# Access Compliance Report

### (Curb Ramps)

Intersection ID: 52521	Main Street: LORNA_ST	Cross Street: MCCLINTOCK_RD	Location: NW
ADA ID: B80923CBB812	Ramp Type: Perp	Initial Pass/Fail: Pass	Overall Compliance: No
		Severity Score: 15

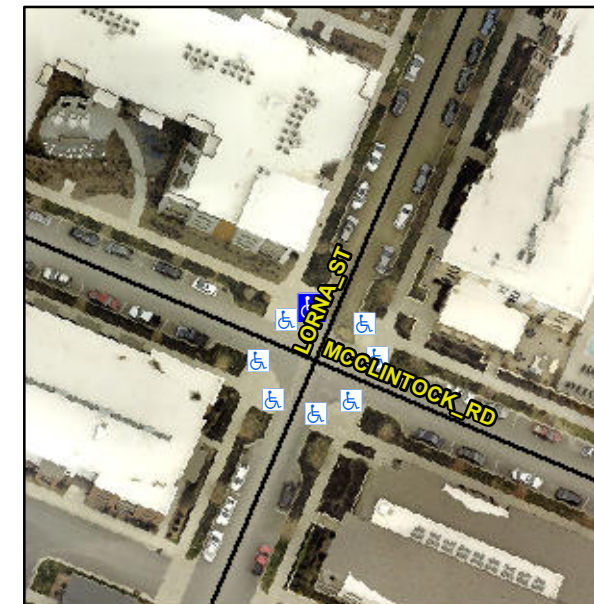
**Remove & Replace Detectable Warning System. Grind Gutter Lip.**

**R305.2, R302.7.2**
